UNITED STATES PATENT AND TRADEMARK OFFICE

APPLICATION NO.	FILING DATE	FIRST NAMED INVENTOR	ATTORNEY DOCKET NO.	CONFIRMATION NO.
10/802,840	03/18/2004	Mikihiko Ishii	119132	5068

Office Action Summary

DETAILED ACTION

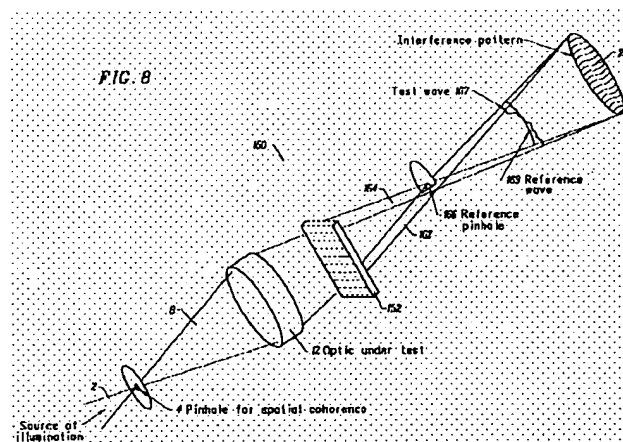
Figure 8 should be designated by a legend such as --Prior Art-- because only that which is old is illustrated. See MPEP § 608.02(g). Corrected drawings in compliance with 37 CFR 1.121(d) are required in reply to the Office action to avoid abandonment of the application. The replacement sheet(s) should be labeled “Replacement Sheet” in the page header (as per 37 CFR 1.121(d)) so as not to obstruct any portion of the drawing figures. If the changes are not accepted by the examiner, the applicant will be notified and informed of any required corrective action in the next Office action. The objection to the drawings will not be held in abeyance.
